GROUP
Safety Recall

MODEL
**2017-2018MY
Optima Plug-in
Hybrid (JF PHEV)**

NUMBER
SC162

**SUBJECT: HIGH VOLTAGE MAIN & SUB BATTERY
MANAGEMENT (BMS) & WIRING HARNESS REPLACEMENT (SC162)**

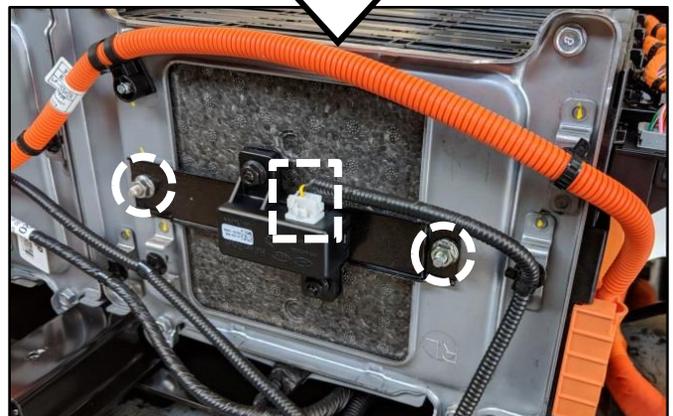
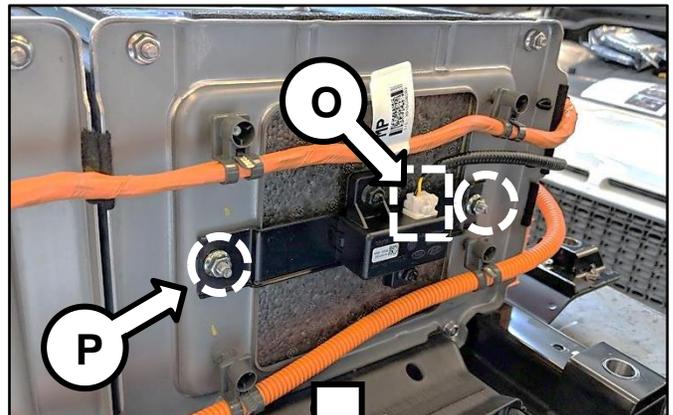
- Disconnect the Voltage Protective Device (VPD) connector (O), then remove the two (2) retaining nuts (P) and remove the VPD located on the back side. Repeat for opposite front side VPD.

Discard the existing Sub-BMS wiring, including VPD with bracket and retaining hardware.

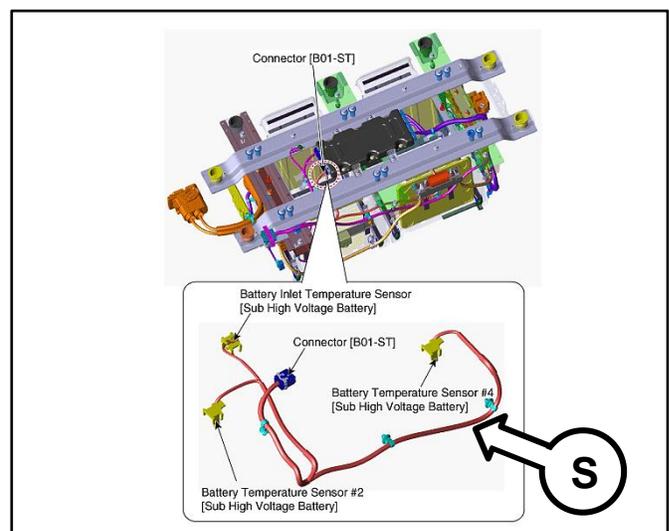
22. Install the new and updated SUB-BMS Wiring harness (S) in the reverse order of removal.

The new and updated SUB-BMS Wiring Harness (T) does not feature the Voltage Protective Device (VPD) which has been replaced by the OPD inside the new SUB-BMS.

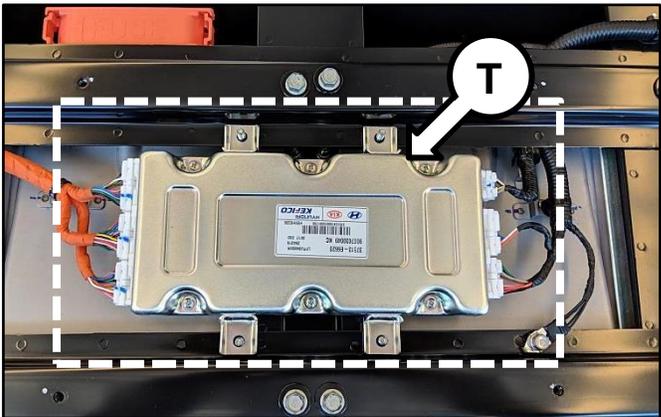
- 25. Install the new SUB-BMS ECU (T) in the reverse order of removal.

*** NOTICE**
Ensure that the **SUB-BMS ECU** connectors click when inserting and are secured into place.

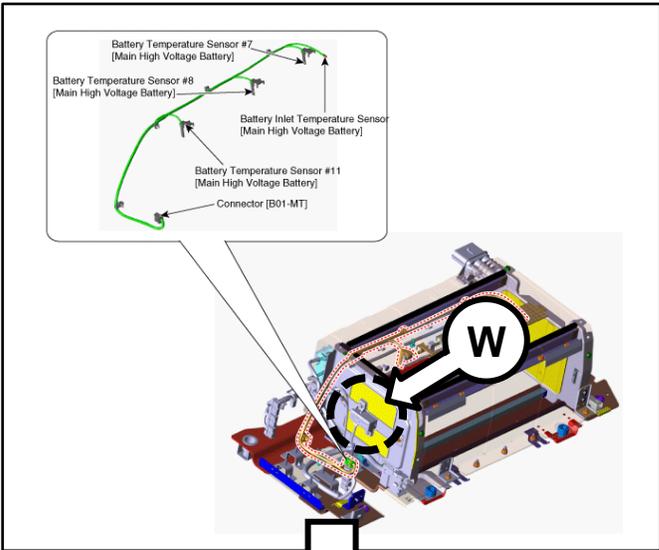
19. Install the new and improved, Main BMS wiring harness, without VPD (W), in the reverse order of removal.

Discard the VPD (W) with bracket and retaining hardware.

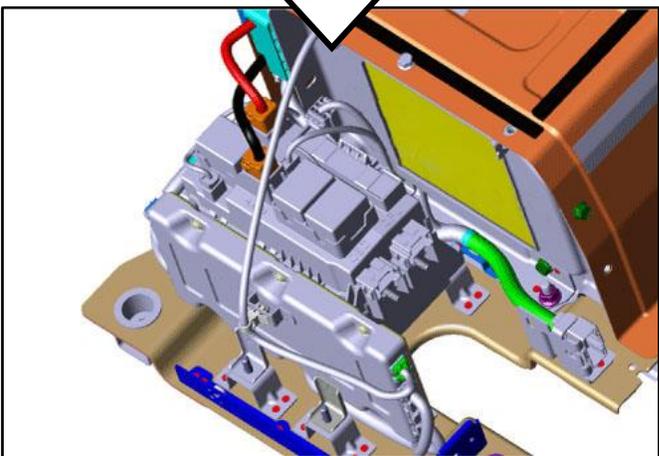
20. Install the new and improved Main BMS ECU to the old PRA assembly in the reverse order of removal.

The new and updated Main BMS Wiring Harness (T) does not feature the Voltage Protective Device (VPD) which has been replaced by the OPD inside the new Main BMS.
